ADDENDUM NO. 1

Date of Addendum: 3/19/15

PROJECT NAME: Northwest Wastewater Treatment Plant Improvements

PROJECT NO: WBS No. R-000265-0095-4

NORTHWEST WWTP
IMPROVEMENTS
NPW SYSTEM FOUNDATION
PLAN SECTIONS AND DETAILS

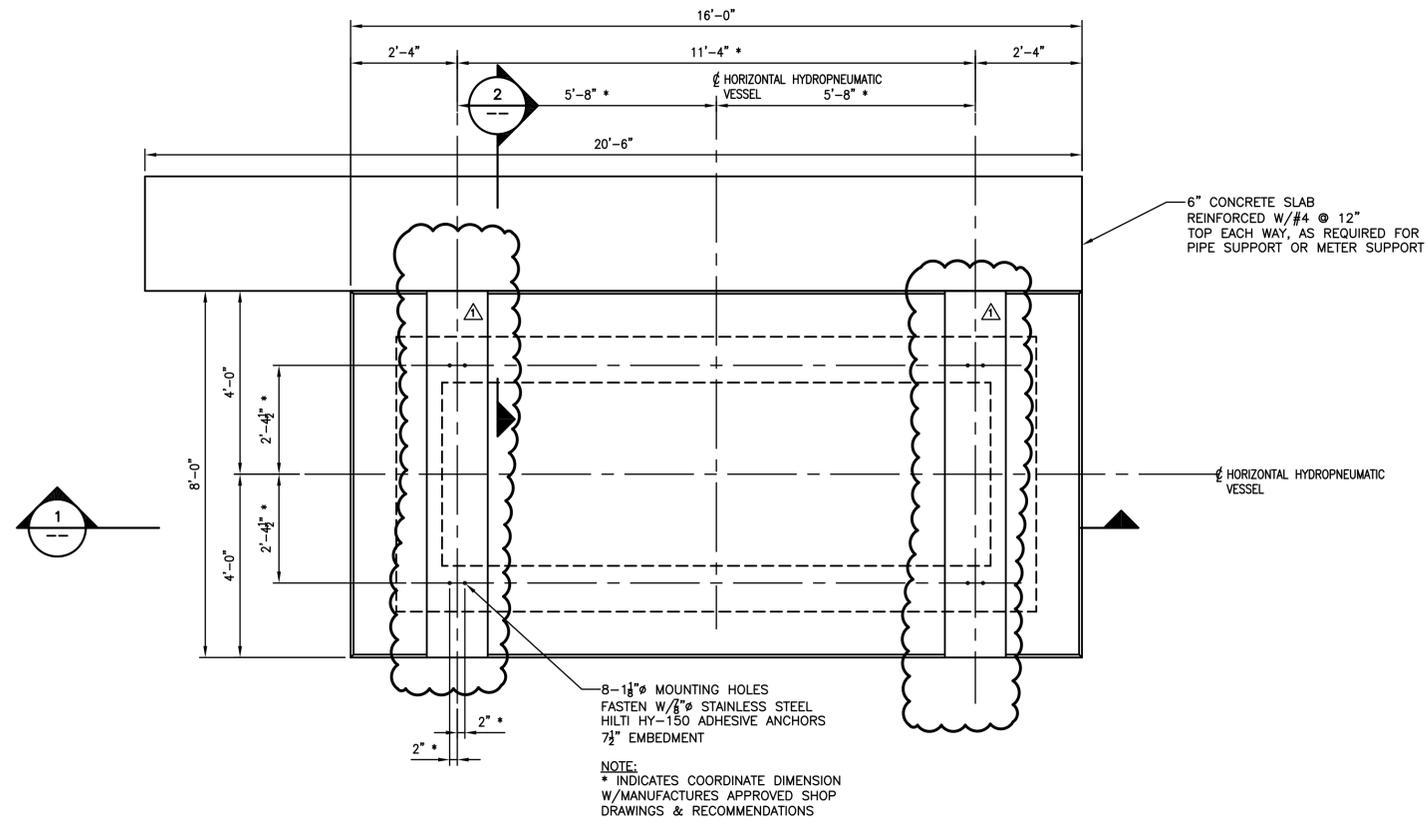
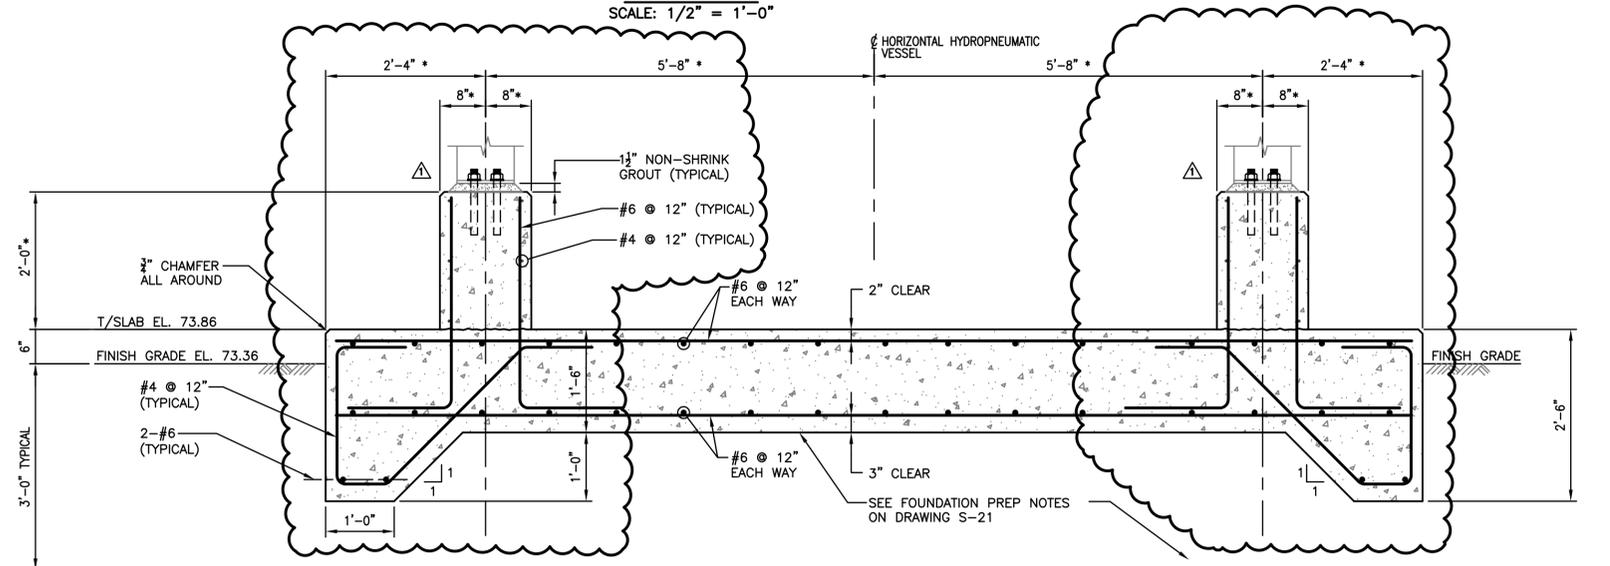
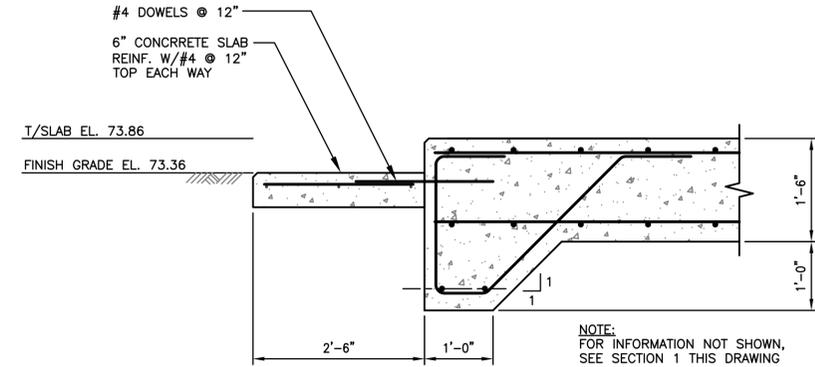
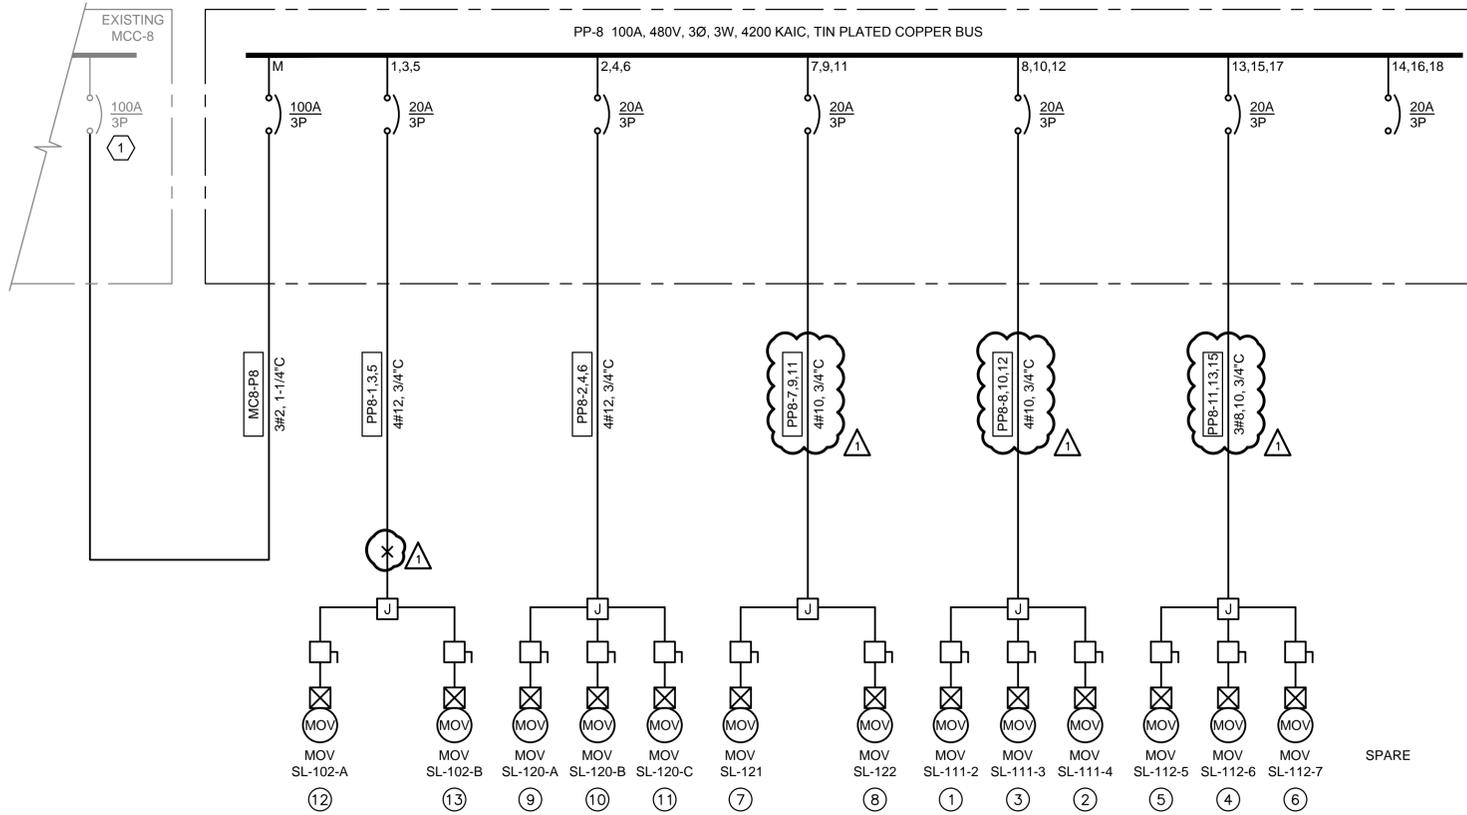
29. S-16 NPW System foundation Plan, Sections, and Details. Concrete saddle details added to Section 1. Add Note "2. Set final elevation after tank is selected. Reference SH M-33."

- NOTES:
- SEE DRAWING S-21 FOR FOUNDATION PREP NOTES.
 - SET FINAL ELEVATION, AND ANCHOR BOLT LOCATIONS AFTER TANK IS SELECTED. REF M-33.

NORTHWEST WWTP IMPROVEMENTS ELECTRICAL WAS/SCUM MODIFICATION PLAN

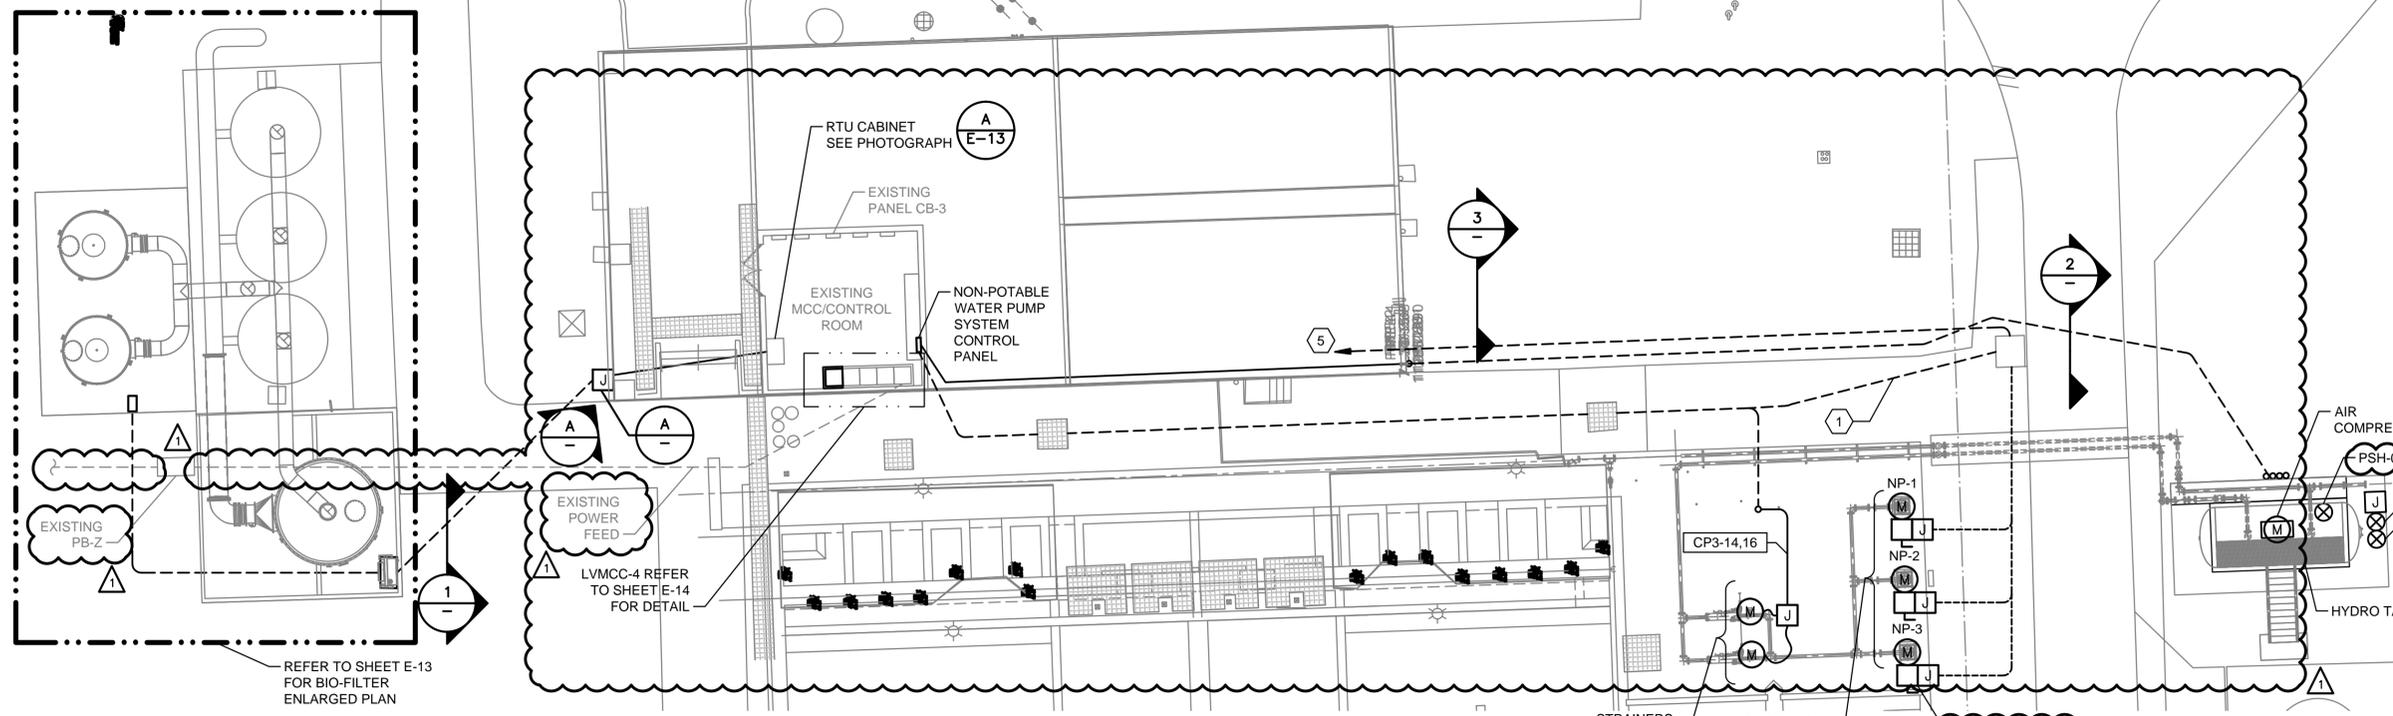
46. Per sheet 26, detail 2 scum & screw conveyor control panel doesn't match on sheet 27 detail 1. Sheet 27 shows conduits SCUM1P and SCUM1C between MCC-9 and control panel. Sheet 26 shows MC9-6P through MC9-9P and MC9-6C through MC9-9C and MCC – 9 and control panel. Please Clarify.

Refer to revised drawings E-10 (sheet 26) and E-11 (sheet 27) for clarifications per Addendum No. 1

CITY OF HOUSTON
DEPARTMENT OF PUBLIC WORKS AND ENGINEERING
NORTHWEST WWTP IMPROVEMENTS
ELECTRICAL
NON-POTABLE WATER SYSTEM
PLAN AND DETAIL

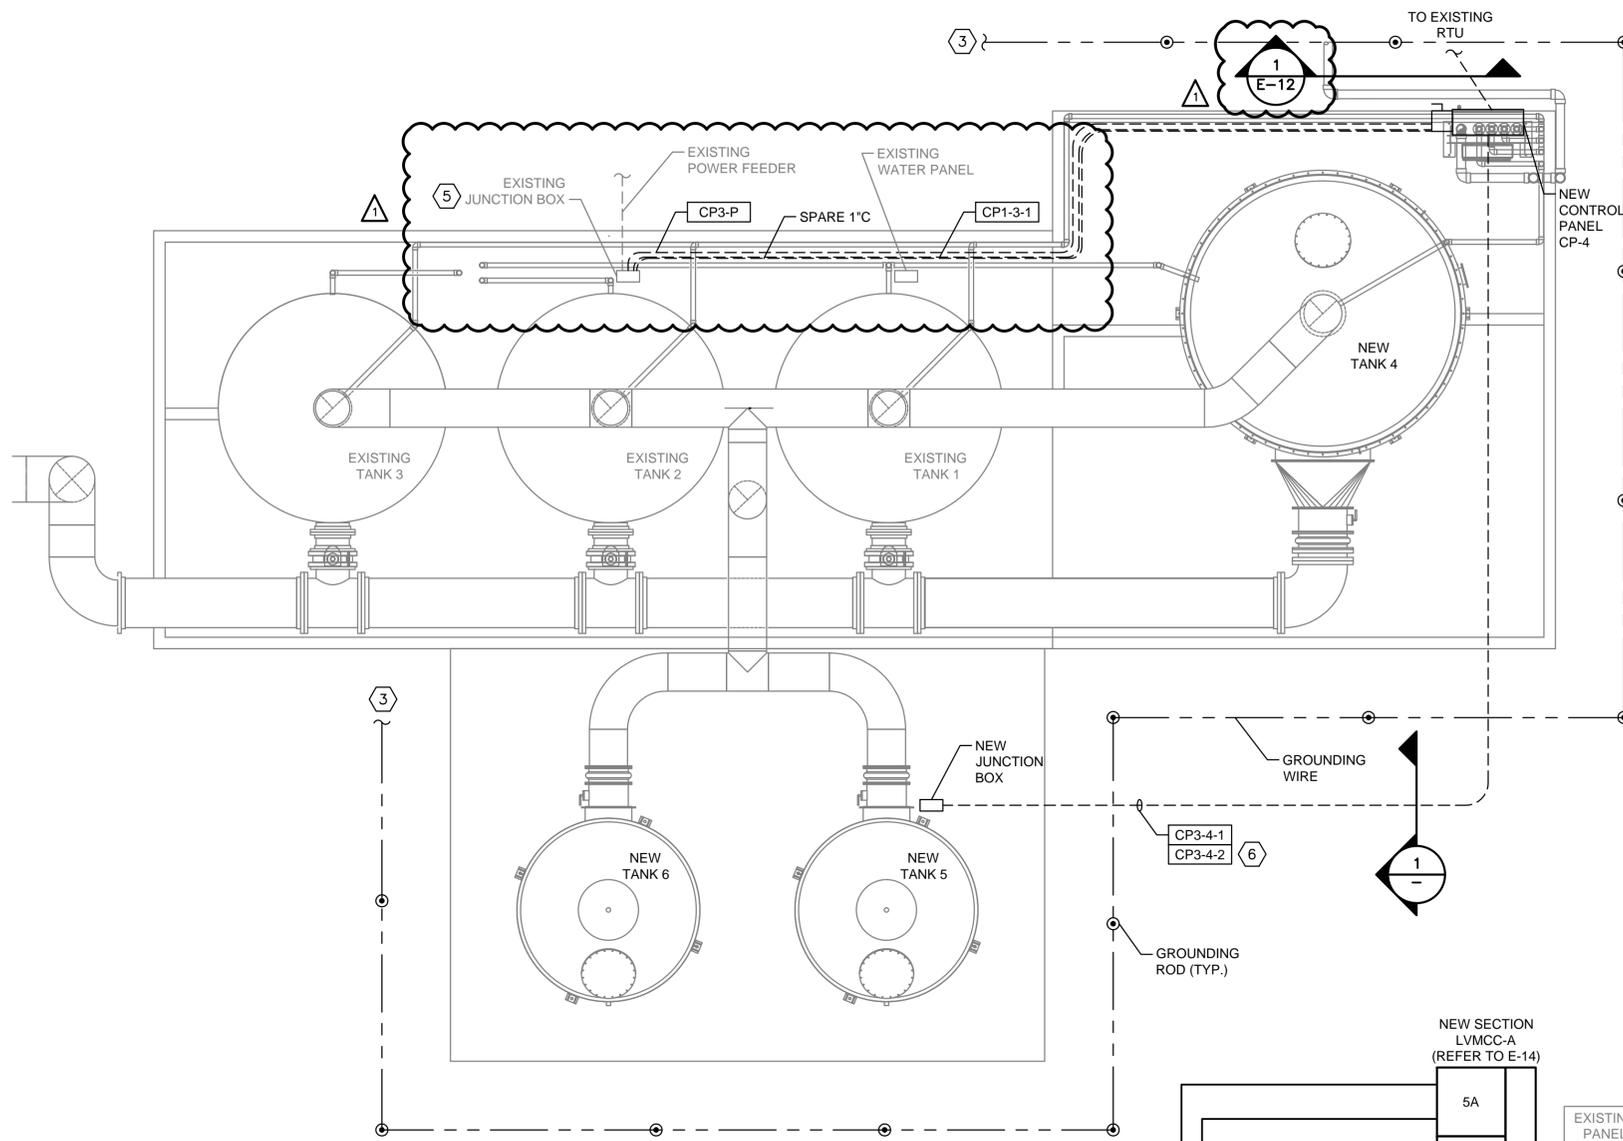
52. Per Sheet 28, Note 1 states to verify conduits are suitable for use. If not, how is the contractor to be paid to install the required conduits?

Refer to revised E12 (sheet 28) for alternative ductbank detail if the existing conduits are not usable and use Extra Unit Price Item for installation.

NORTHWEST WWTP IMPROVEMENTS
ELECTRICAL
BIO-TRICKLING FILTER PLAN

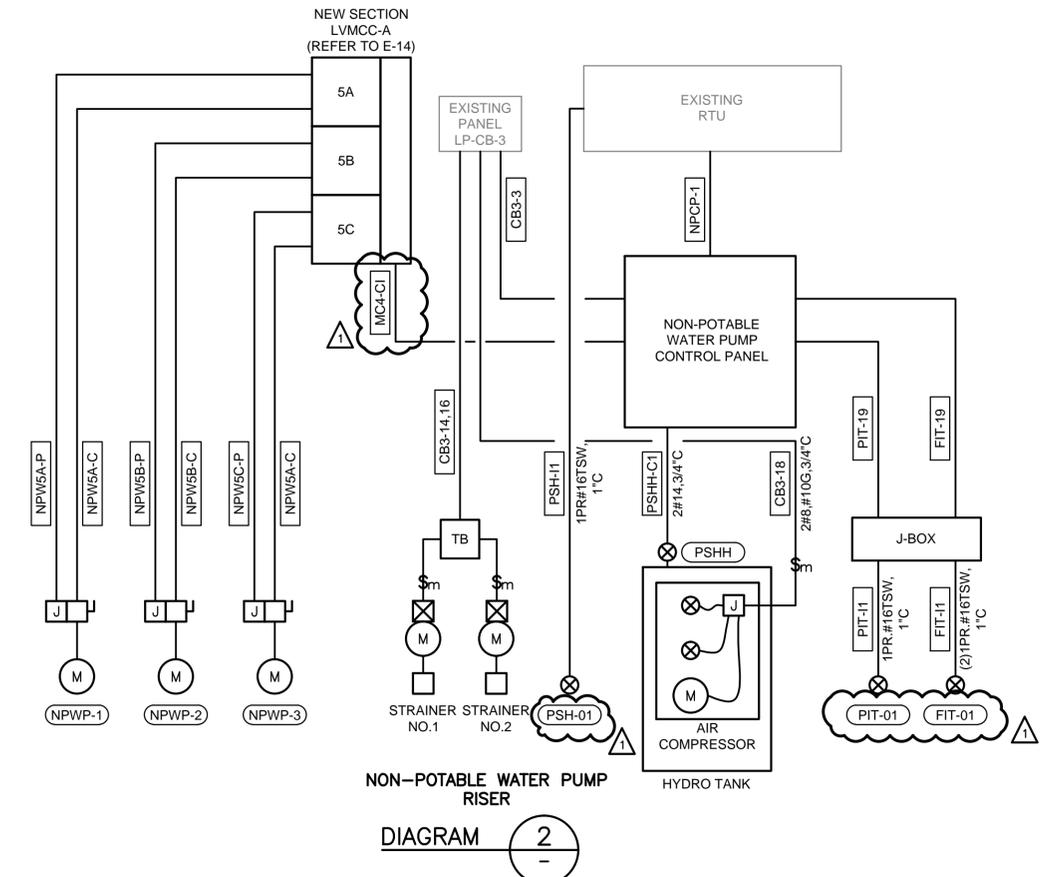
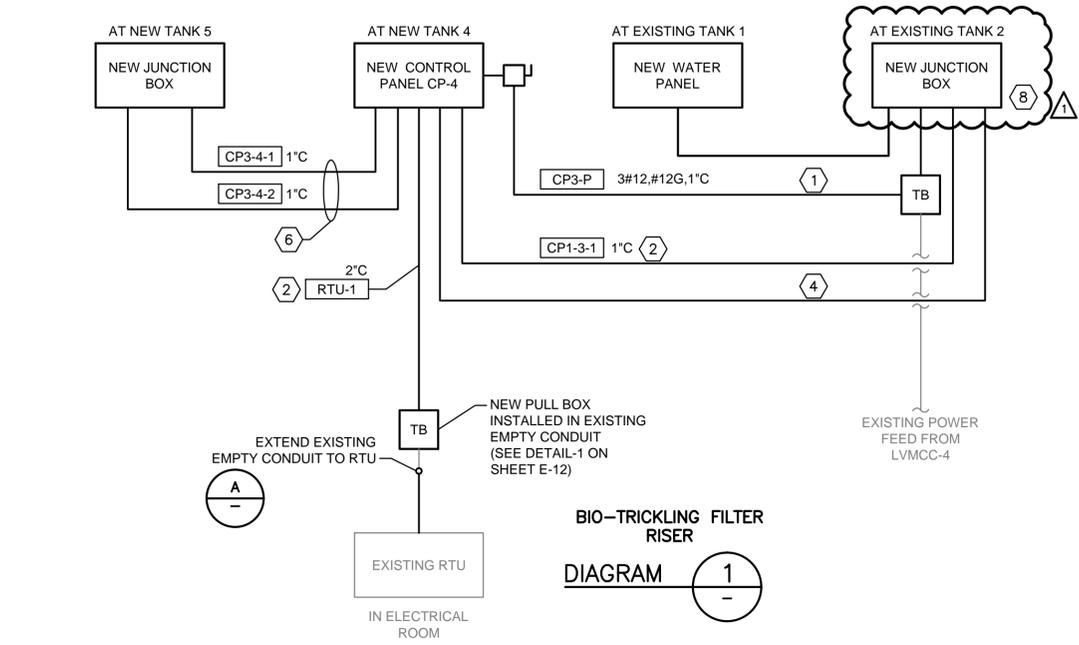
56. Per sheet 29, Detail 1 what size conduit and how many wires are in the conduit from the new water panel to the new junction box at existing Tank 2? Also, Note 2, where is this information stating how many conductors are required?

Refer to revised E13 and E14 for details for clarifications per Addendum No. 1
